World Forum for Harmonization of Vehicle Regulations

Proposal for Supplement 9 to the 03 series of amendments to UN Regulation No. 129 (Enhanced Child Restraint systems)

Submitted by the Working Party on Passive Safety *

Figure 4
Arrangement for Testing a Forward-Facing Device

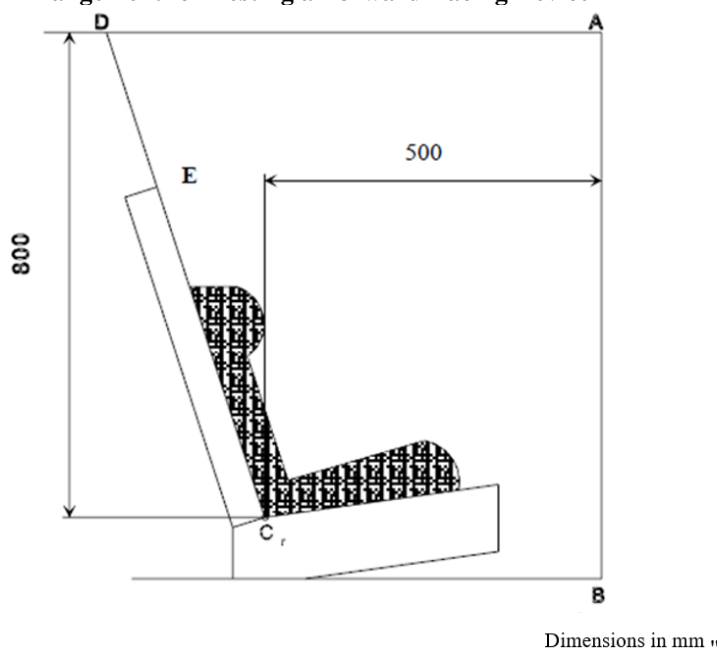
Paragraph 6.6.4.1.1., amend to read:

Integral Enhanced Child Restraints: No part of the head of the dummy shall pass beyond the planes BA, DA and DE as defined in Figure 4 below:

- (a) The value in relation to the BA plane is 500 mm; and
- (b) The value in relation to the DA plane is 800 mm, except when testing with the Q3 or Q6 dummy where the value is 840 mm; and
- (c) However, the head of the dummy may pass beyond the DE plane, if the head pad or the backrest part of the child restraint structure, which is behind the head of the dummy, at the point the head, passes the DE plane; and
- (d) In case of dummy contact with a rigid part of the test bench in the rebound phase, the head acceleration criterion during that contact shall not be considered.

Non-integral booster seat: No part of the head of the dummy shall pass beyond the planes BA and DA as defined in Figure 4 below.

- (a) The value in relation to the BA plane is 550 mm; and
- (b) The value in relation to the DA plane is 840 mm; and
- (c) The rebound phase is not considered for the assessment of the plane DA.

Non-integral booster cushion: No part of the head of the dummy shall pass beyond the planes BA and DA as defined in Figure 4 below.

- (a) The value in relation to the BA plane is 550 mm; and
- (b) The value in relation to the DA plane is 840 mm; and
- (c) The rebound phase is not considered for the assessment of the plane DA; and
- (d) In case of dummy contact with a rigid part of the test bench in the rebound phase, the head acceleration criterion during that contact shall not be considered.

Side view of the support leg dimension assessment volume

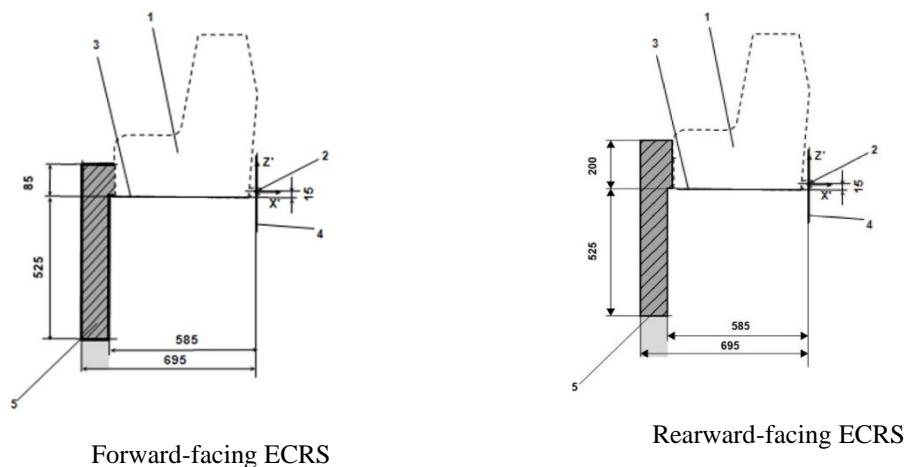
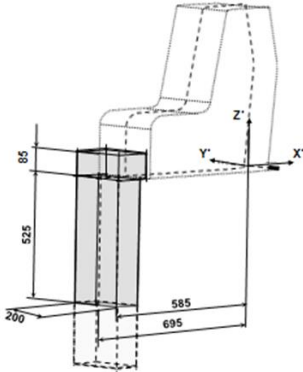
Annex 19., Figure 1, amend to read:

1. Enhanced Child Restraint Fixture (ECRF).
2. ISOFIX low anchorages bar.
3. Plane formed by the bottom surface of the ECRF, which is parallel to and 15 mm below the X'-Y' plane of the coordinate system.
4. Z'-Y' plane of the coordinate system.
5. Upper part of the support-leg dimension assessment volume, which shows the dimensional limitations in X' and Y' direction, the upper height limit in Z' direction, as well as the lower height limitation in Z' direction for rigid, not in Z' direction adjustable support leg components.

"Figure 2
3D view of the support leg dimension assessment volume

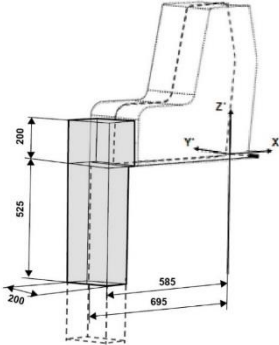
Annex 19, Figure 2, amend to read:
